Re: **Initial Submission Review – Porteos** (Infrastructure CSP)
Application Number: **DA-1903-13**
Case Number(s): **2019-6032-00**

INFRASTRUCTURE CONTEXTUAL SITE PLAN NO.5 AT PORTEOS

INFRASTRUCTURE SITE PLAN
E. 64TH AVENUE PLAN VIEW

Notary Business Address: _____

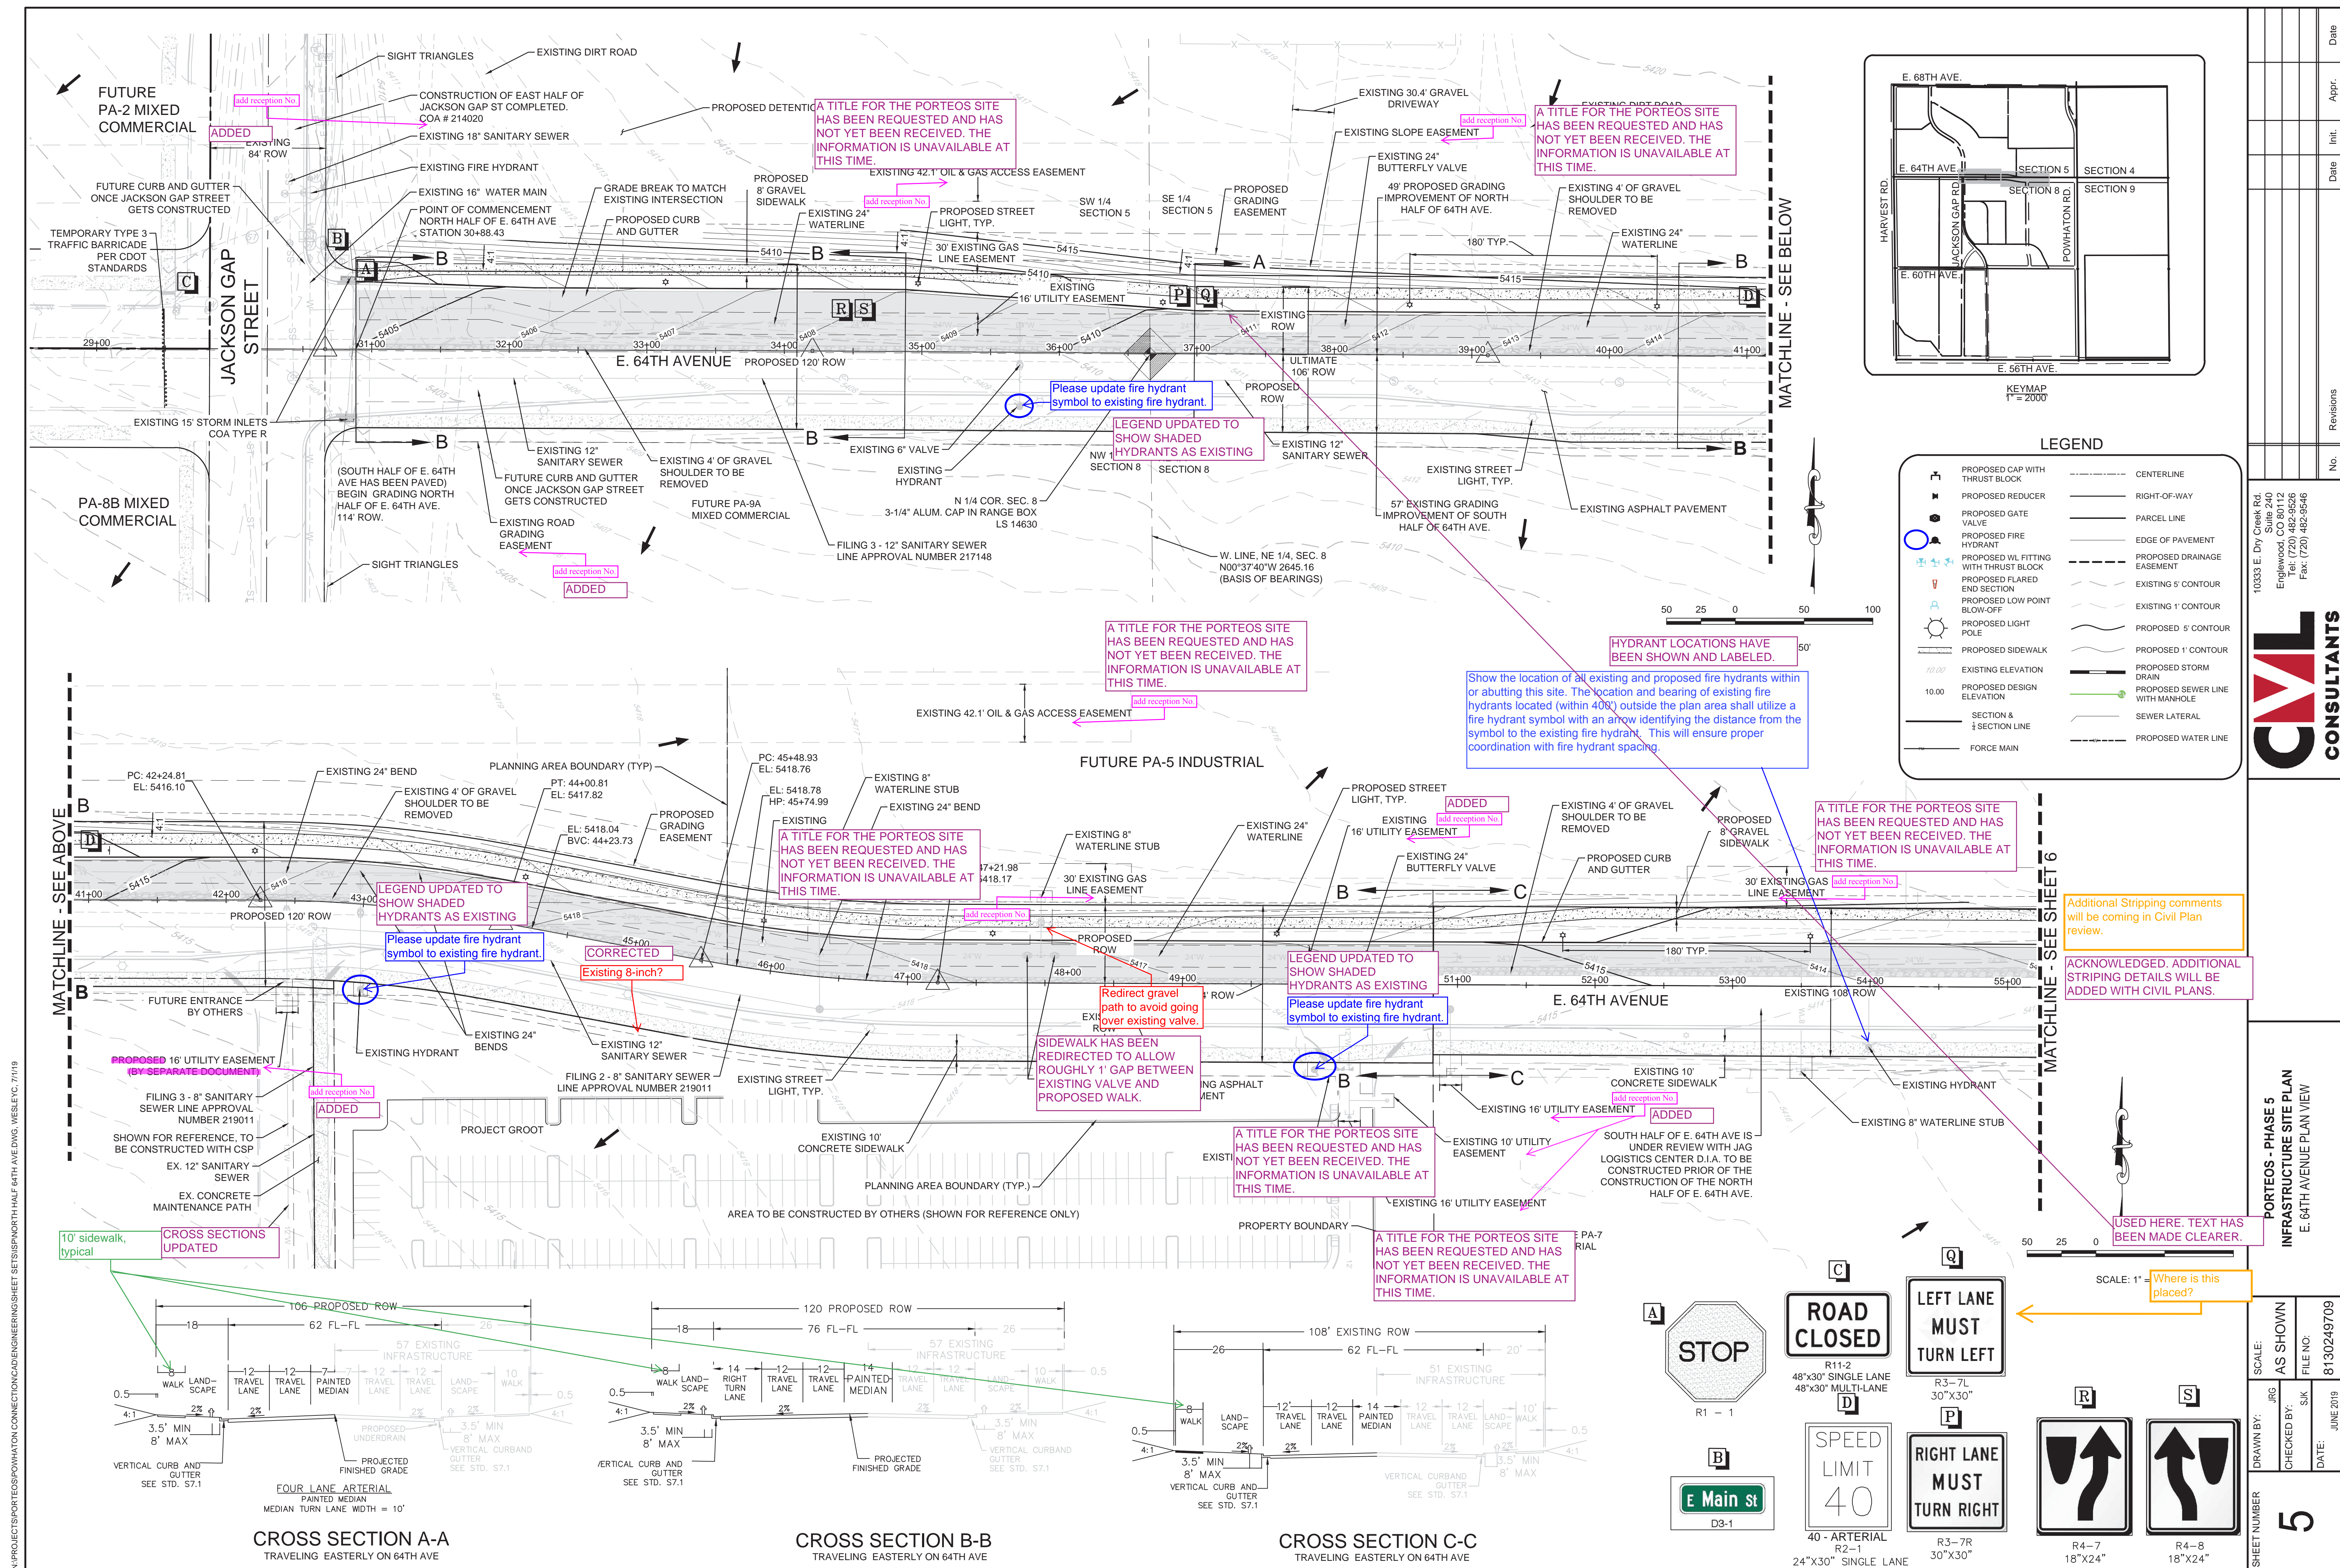
Proposed laneages do not match NEATS. Ensure proposed laneages match NEATS and Traffic Memo auxiliary lane recommendations to CDOT SHAC. Provide dimensions for all auxiliary lanes.

The site plan will not be approved by public works until the preliminary drainage letter/report is approved

Please remove AutoCad SHX text items in the comment section. Please flatten to reduce select-ability of the items.

Response: Laneage now matches traffic study.

Response: Acknowledged.

Response: SHX text has been removed.

CROSS SECTION C-C
TRAVELING EASTERLY ON 64TH AVE

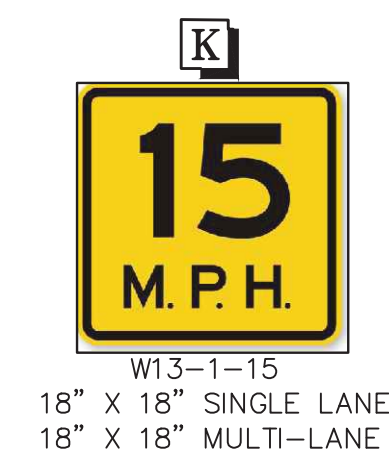
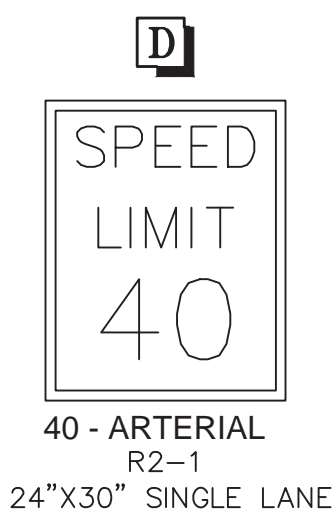
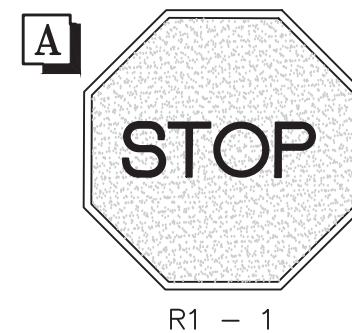
Additional Stripping comments
will be coming in Civil Plan
review.

ACKNOWLEDGED. ADDITIONAL STRIPING DETAILS WILL BE ADDED WITH CIVIL PLANS.

SHEET NUMBER
9

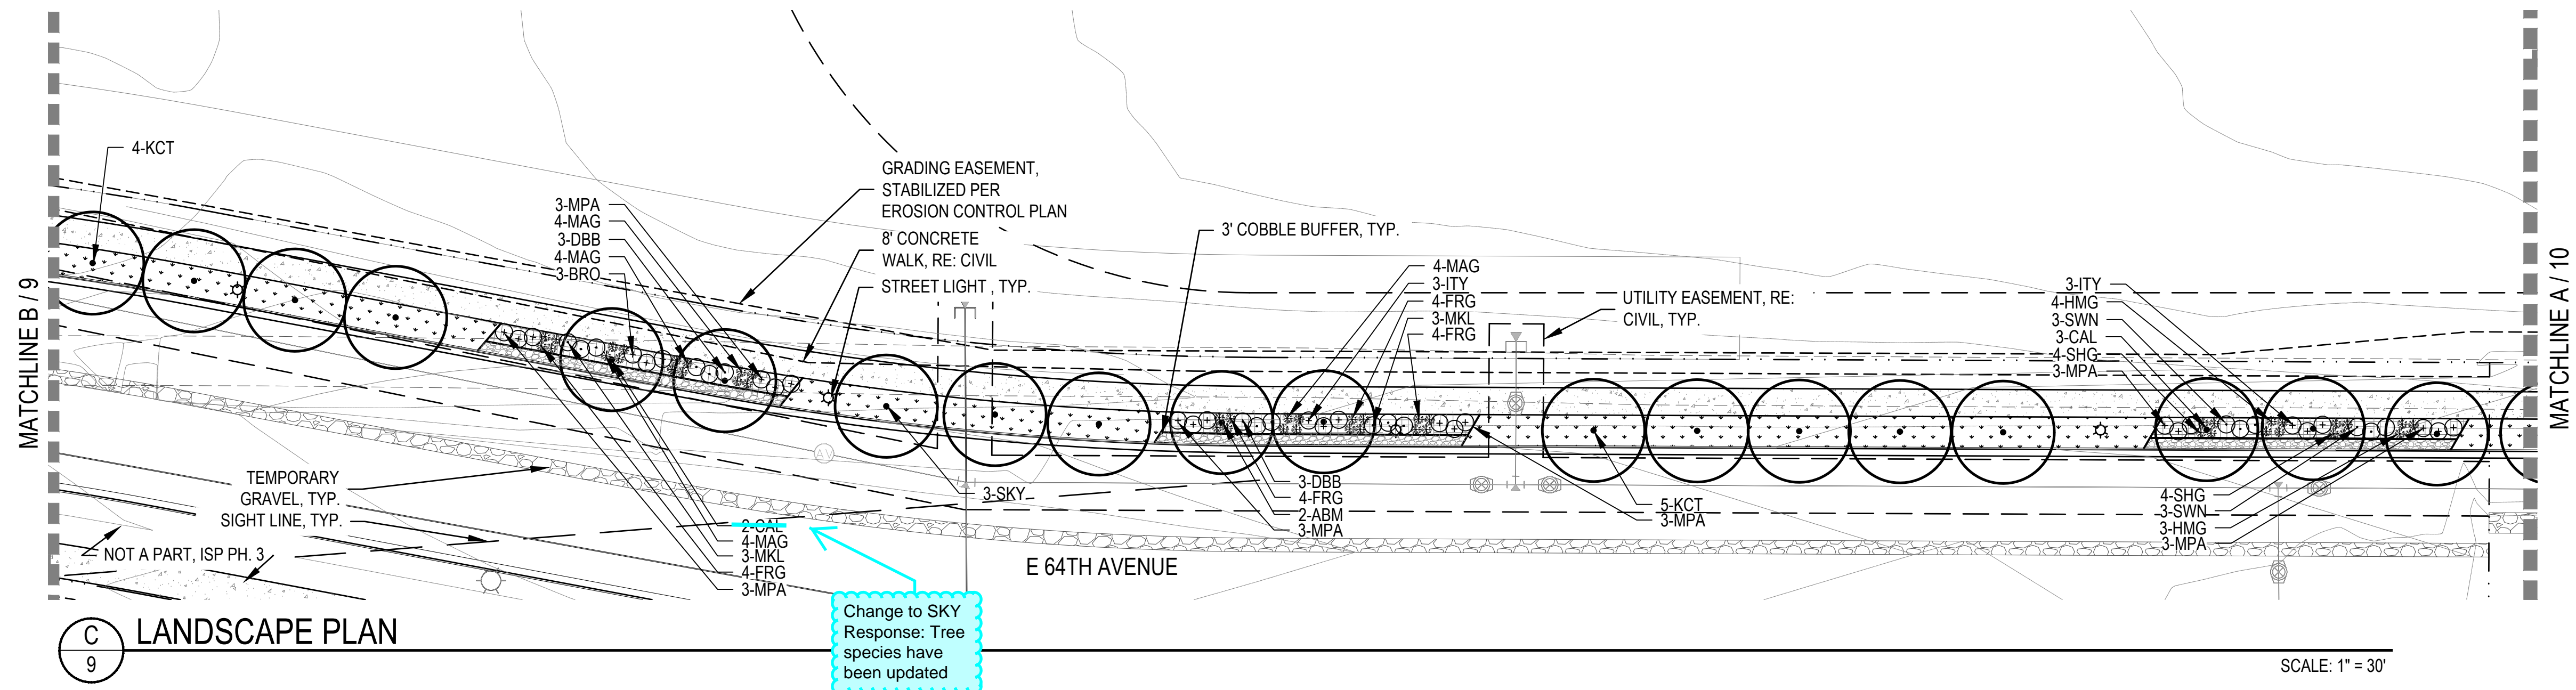
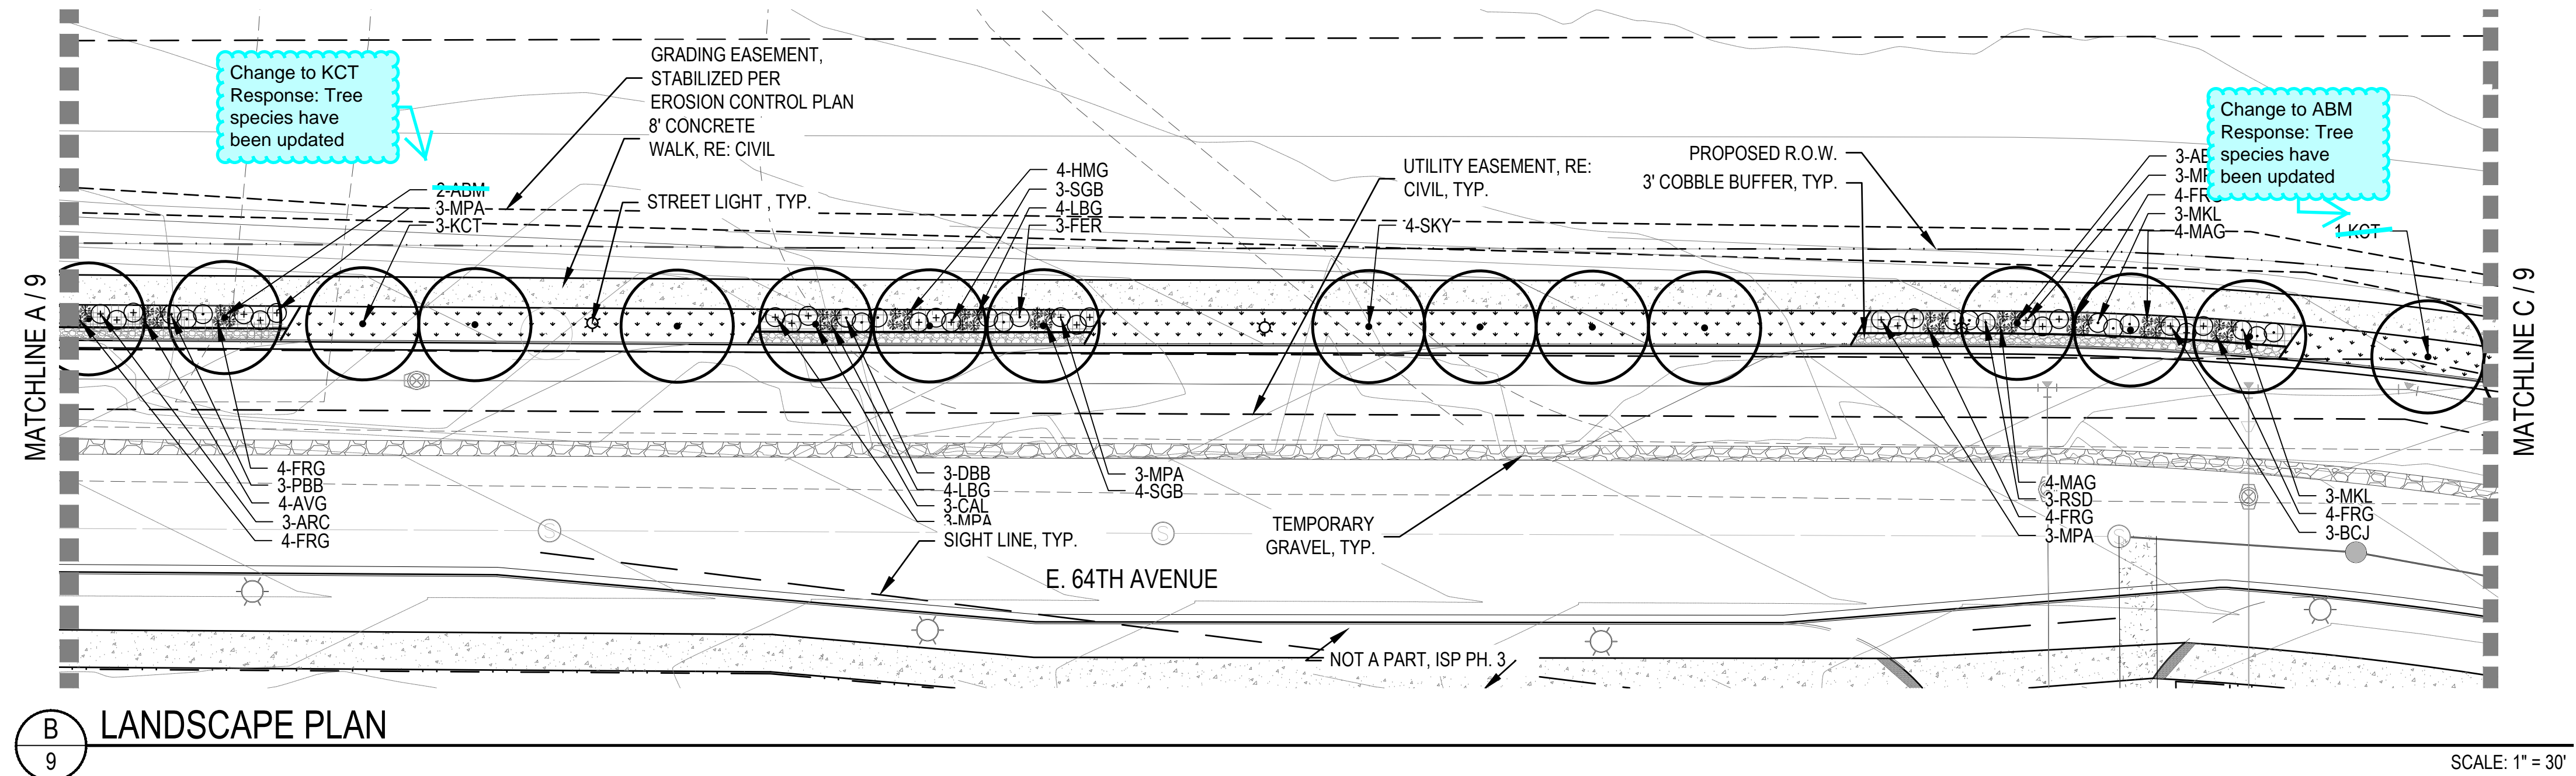
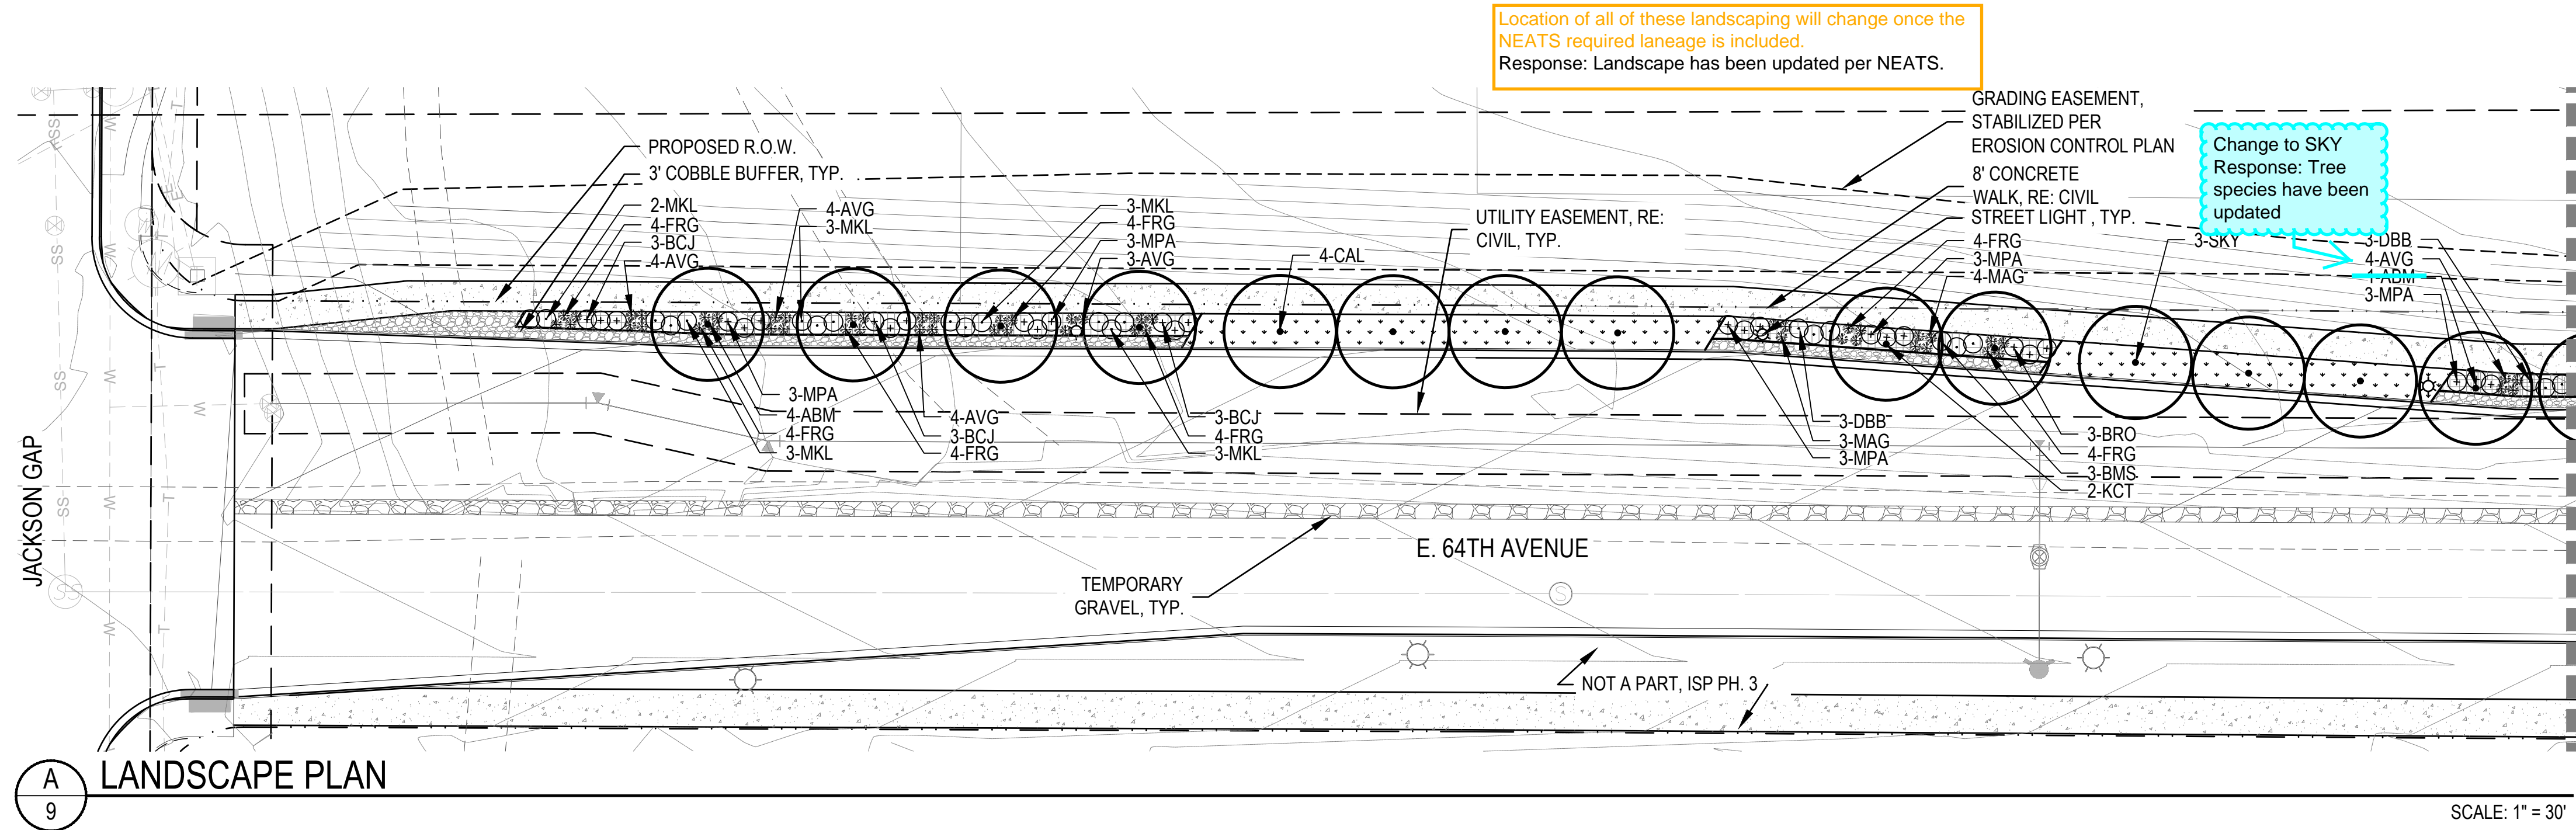
Please refer to Utility sheets for fire life safety comment. Fire hydrant locations shall be located on landscape plans.
Response: Fire hydrant locations are now shown on landscape plan.
